Austar Coal Mine Pty Ltd

Proposed Stage 2 Extension Project Response to Submissions

September 2010

FIGURE 3.1

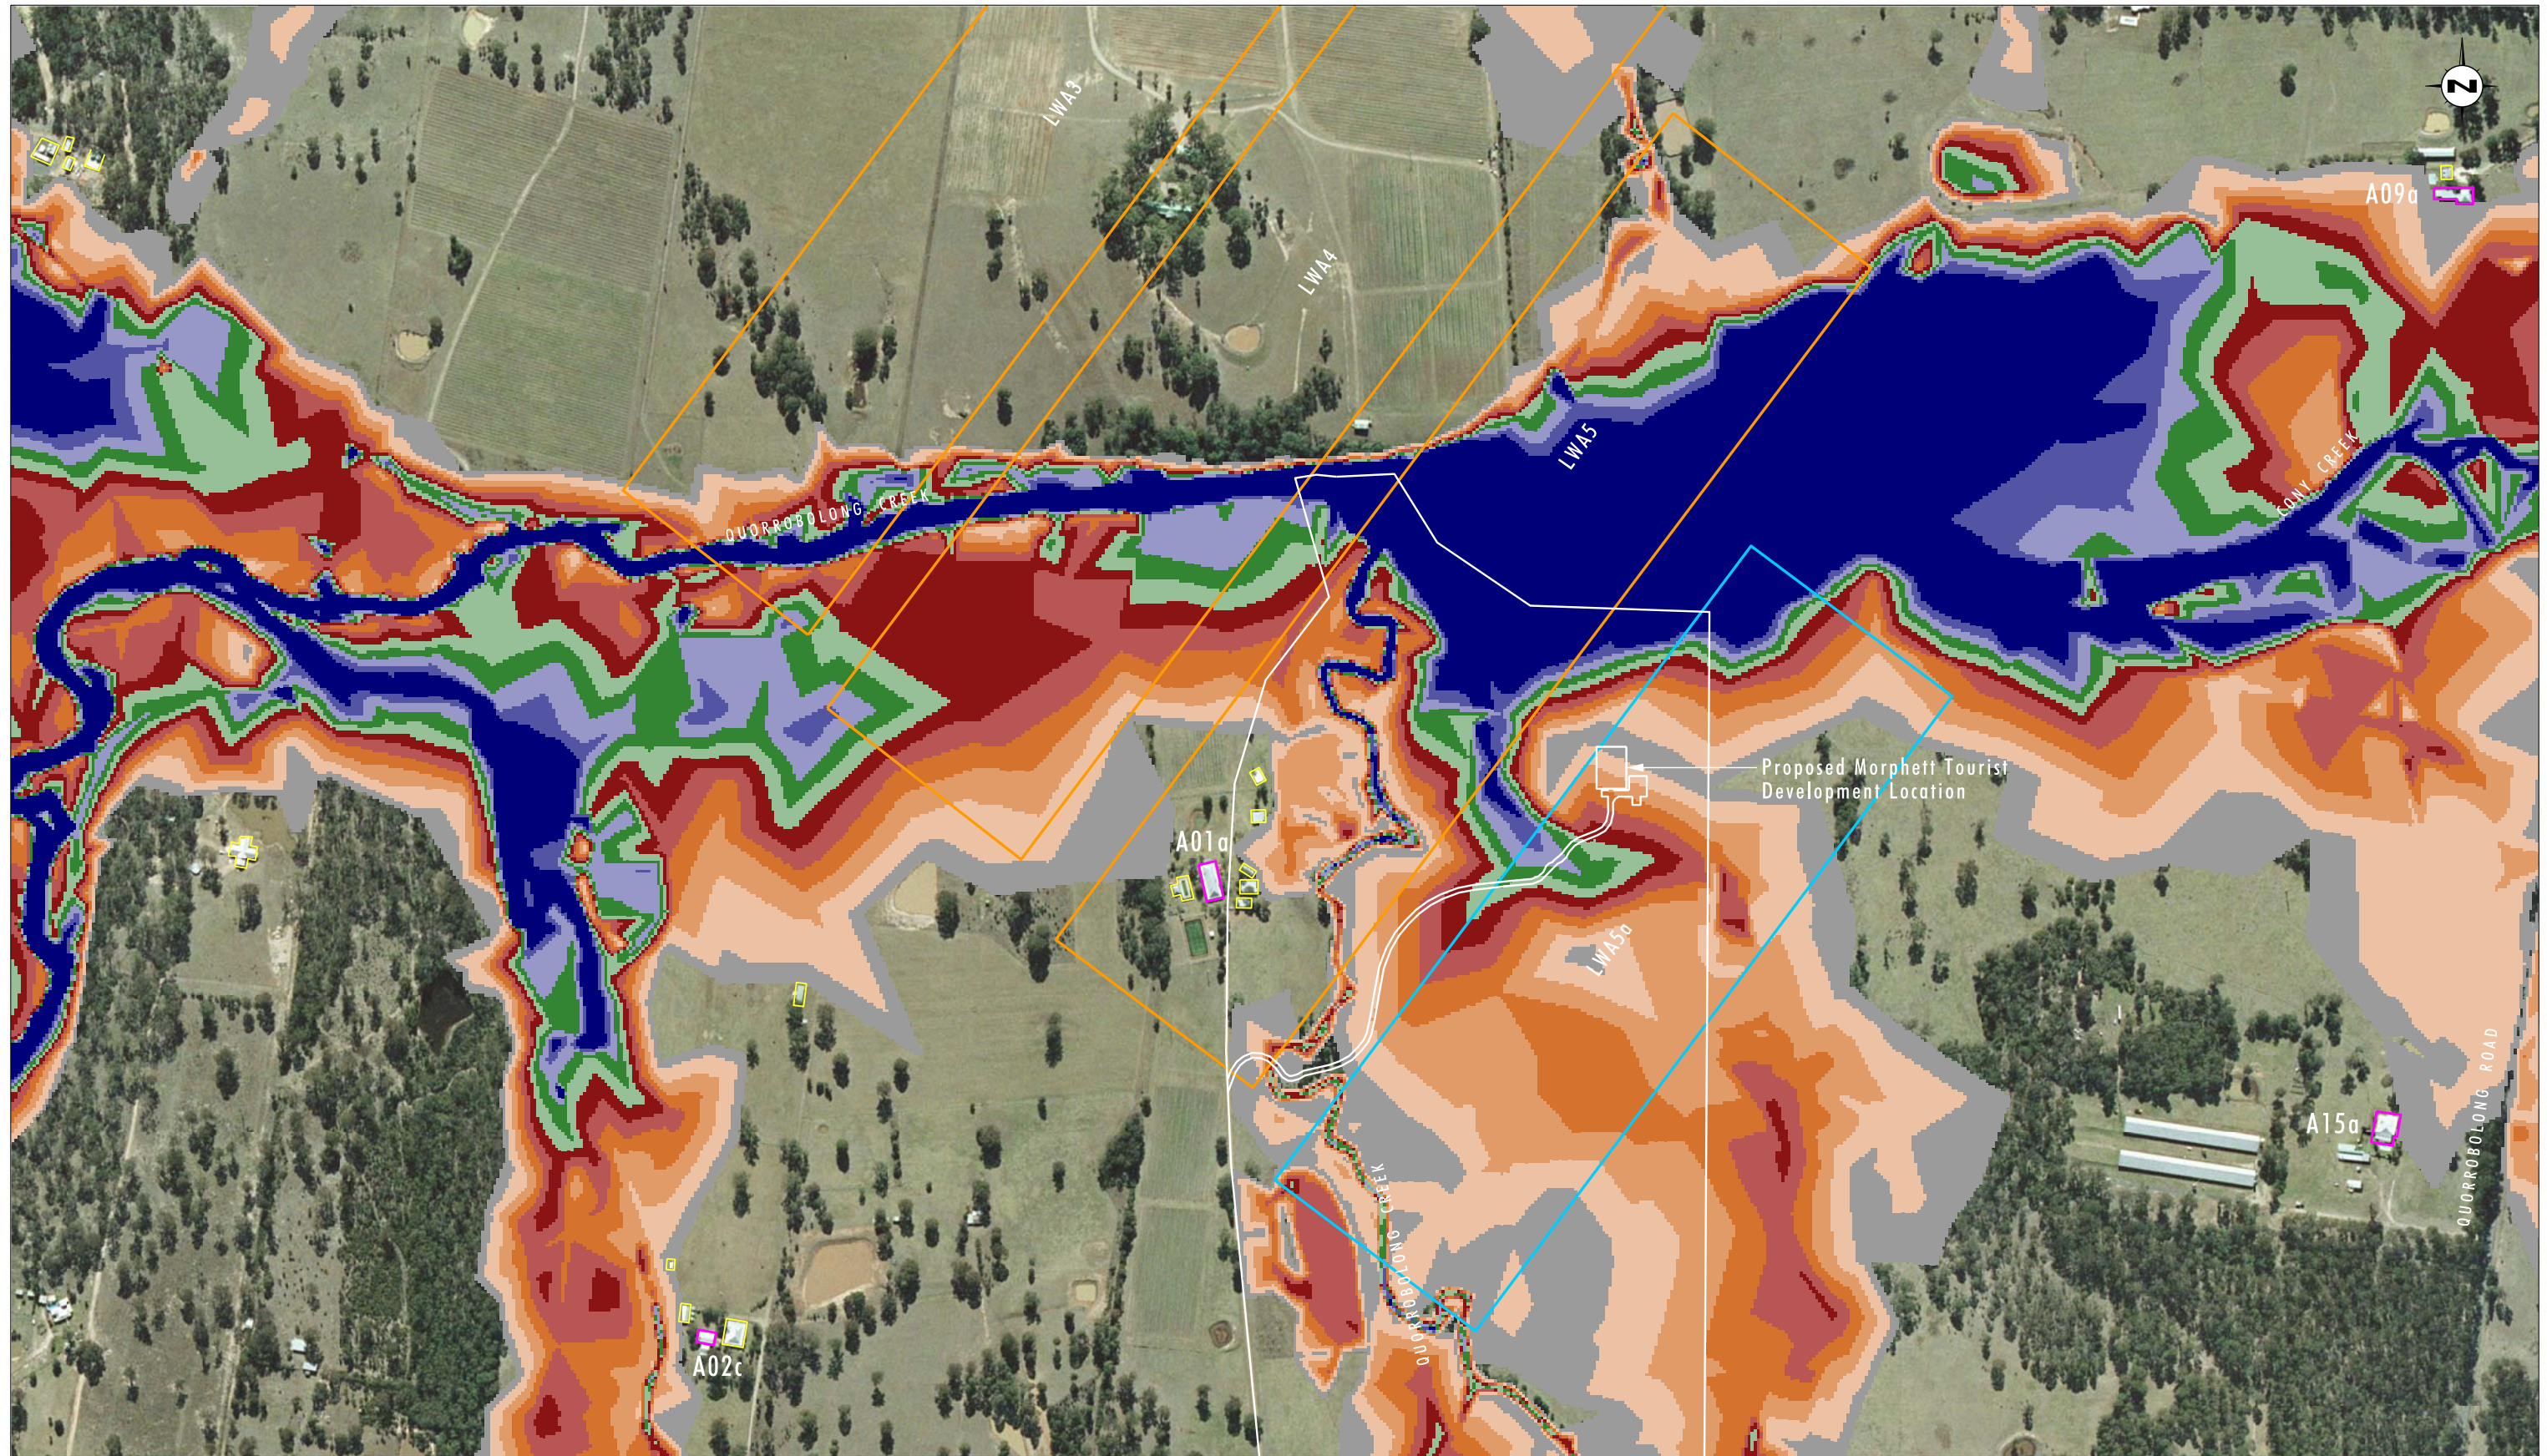
5. My proposed tourist development would be subjected to subsidence that would deem the property as unsafe, unserviceable and unrepairable. Flooding of the complex would occur annually.

The location of the proposed tourist development in relation to flood depths resulting from the pre-Stage 2 mining landform, predicted post-Stage 2 mining landform (i.e. after mining of LW A3 to LW A5 as approved) and predicted post-Stage 2 Extension mining landform (i.e. after mining of proposed LW A5a) is shown on **Figures 3.1, 3.2, and 3.3** respectively. As shown on **Figures 3.1 and 3.2** the proposed access road to the tourist accommodation building crosses Quorrobolong Creek via a low level crossing that would be impassable during the 100 year flood event for the pre-Stage 2 mining landform and the post-Stage 2 mining landform. The access road also passes through areas to the east of Quorrobolong Creek which are subject to flooding to a depth of up to 0.7 metres during the 100 year flood event for the pre-Stage 2 mining landform and the post-Stage 2 mining landform (**Figures 3.1 and 3.2**), meaning that the proposed tourist development access route would be impassable at several locations.

The proposed tourist accommodation building itself is located in an area on the edge of the 100 year ARI flood extent (**Figures 3.1 to 3.3**). It is likely that the building could be subject to flood depths in the order of 100 mm to 300 mm in a 100 year ARI flood event prior to mining of LW A5a (**Figure 3.2**). Following mining of LW A5a the building could be subject to flood depths in the order of 300 mm to 500 mm in a 100 year ARI flood event (**Figure 3.3**). It is noted that the mining of LW A5a is predicted to return maximum flood depths at this location to depths similar to pre-Stage 2 mining conditions (**Figures 3.1 and 3.3**). It is considered that the floor level of the tourist development could be raised to a level that will avoid flooding impacts.
